PLANNING COMMISSION STAFF REPORT

Originator Cary Teague Community Development Director	Meeting Date March 28, 2013	Agenda # VI.A File # 2012.014.12a
-----------------------------------------------------------------------	---------------------------------------	--------------------------------------------------------------

Project Description

As a result of the sketch plan review process recently completed by the applicant, Frank Sidell, has submitted a revised proposal to subdivide the Sidell family-owned property located in between Littel Street and Morningside Road into eight lots. (See property location on pages A1–A5.)

PRELIMINARY UTILITY PLAN

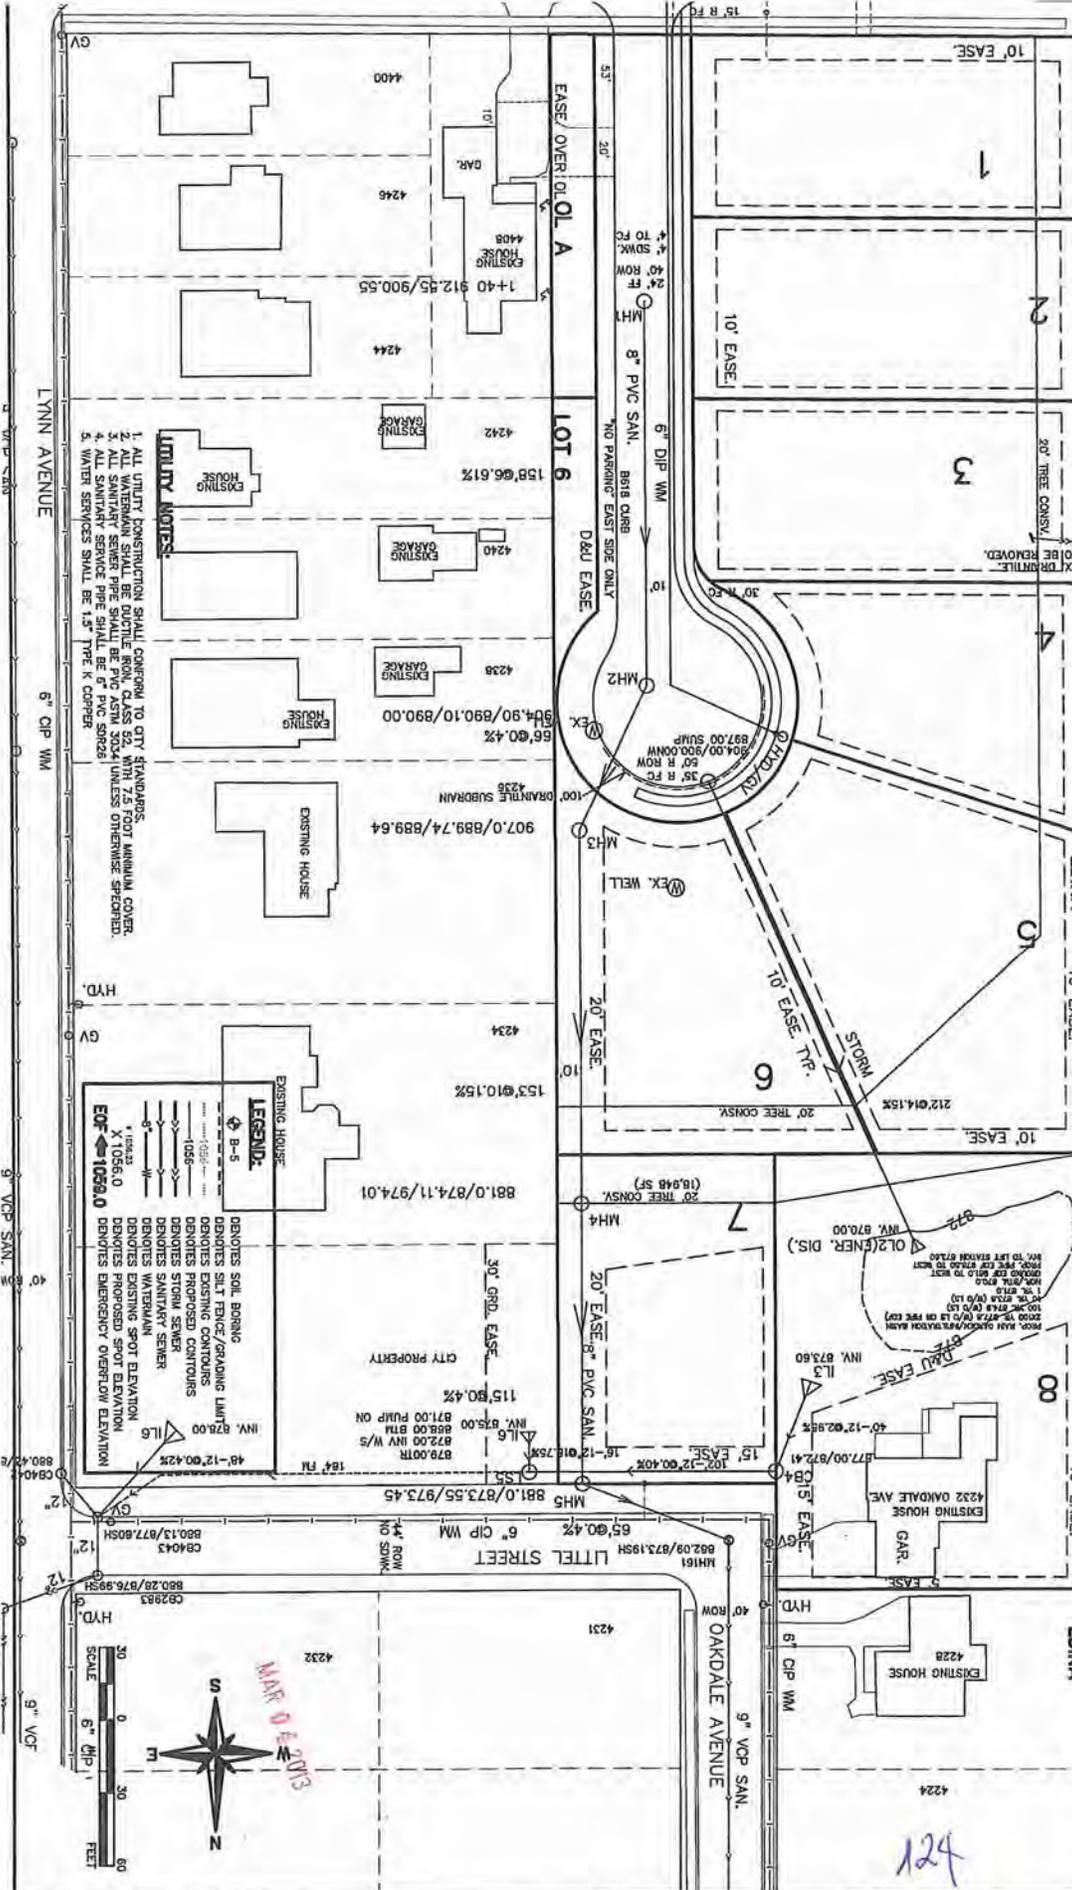
- Provide additional easement for access to maintain proposed rain garden / infiltration basin located at Lot 8.
- Provide storm water calculations for the project. Per the City of Edina's Comprehensive Surface Water Management Plan, verify that the proposed rain garden located at proposed Lot 8 can provide a two foot clearance to surrounding structures by providing storage for a concurrent 100-year single rainfall event or a 100-year 10-day snowmelt, whichever is greater.

PRELIMINARY GRADING AND EROSION CONTROL PLAN

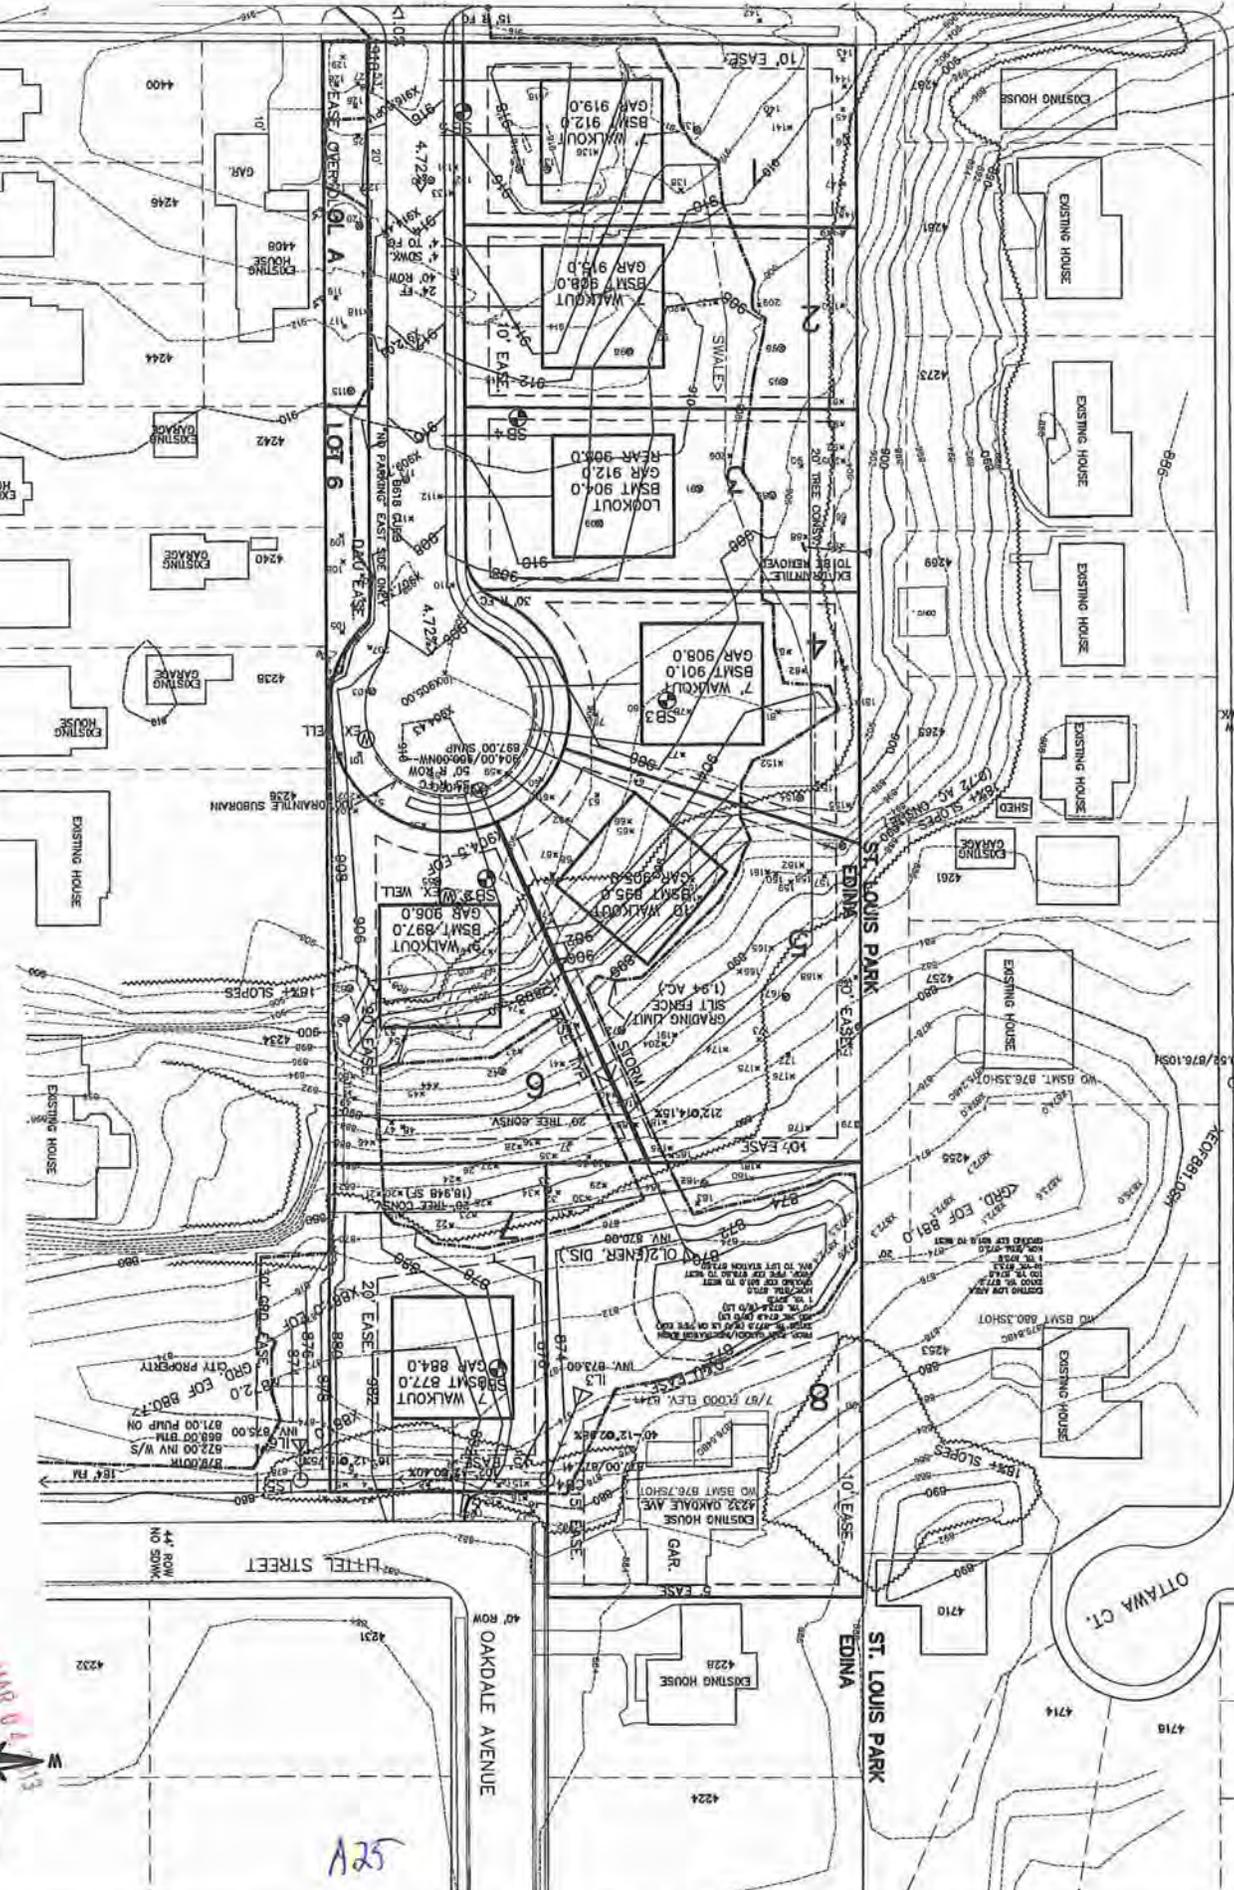
- Use of City property adjacent to proposed Lot 7 will require compensation to the City, along with a restoration plan approved by the City Council. Compensation will be calculated as a temporary construction easement. Staff does not support the placement of a retaining wall at this location due to long term maintenance adjacent to proposed sanitary sewer and water main.

Modified Original Proposal

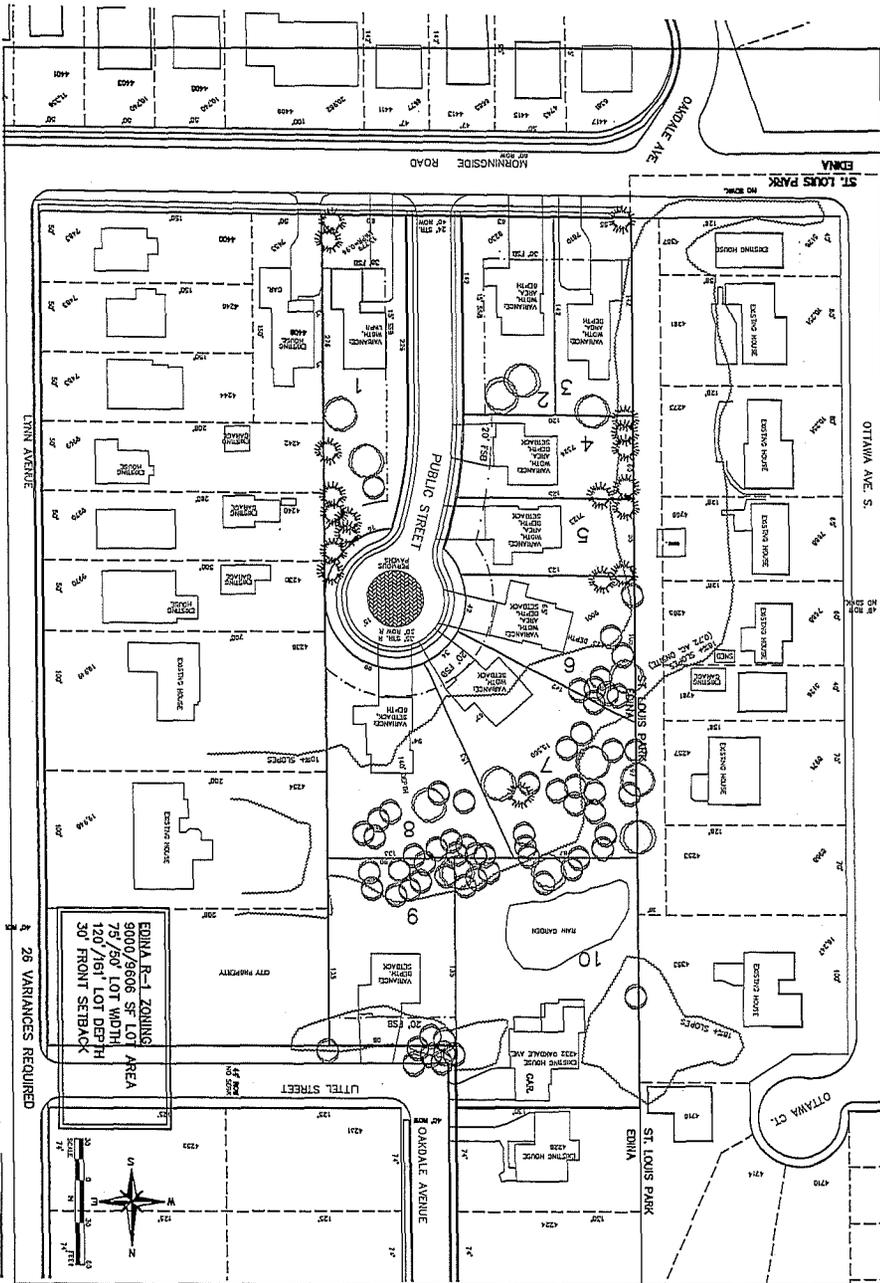
The Council discussed the elements proposed in each of the three concepts and unanimously preferred the modified original concept because it would lower density with 75-foot lots that created pleasant space between houses that residents prefer, preserve the grand tree canopy, maintain the charm, beauty, and serenity of the original 50-acre park-like estate. Support was expressed for the conservation easement, thoughtful rain garden feature, pervious paver roadway enhancement, and 18-foot westerly shift in the roadway.

Commissioner Schroeder said with regard to sketch plan concepts A & B that in his opinion the lots fronting Morningside Road would appear disconnected from the rest of this development. Schroeder said that whatever is decided this development will become "its own thing", a unique and different "neighborhood", and part of the Morningside area of Edina. Continuing, Schroeder said in his opinion the "new" street should be developed as a dynamic living experience. He also suggested thinking of the cul-de-sac in a different way; possibility shifting it slightly and playing with the geometry of the street thereby creating a "living" fluid street. Schroeder said he's not concerned with lot size; however, wants this street and these houses to become a unique dynamic part of Edina. Concluding, Schroeder said he wants to see a great street developed.

Commissioner Forrest said she was opposed to the through street adding she is also hesitant on supporting the concept of fronting homes on Morningside Road. She said these houses would be isolated from the rest of the development. Continuing, Forrest agreed with Schroeder's suggestion of "playing" with the street. Concluding, Forrest said she would like the Sidells to keep their high redevelopment standards and work closely with developer(s), concluding her preference is the modified original concept.

Chair Grabiell stated he also supports the modified original concept, adding he agrees with Commissioner Schroeder that this development will be its own micro-neighborhood.
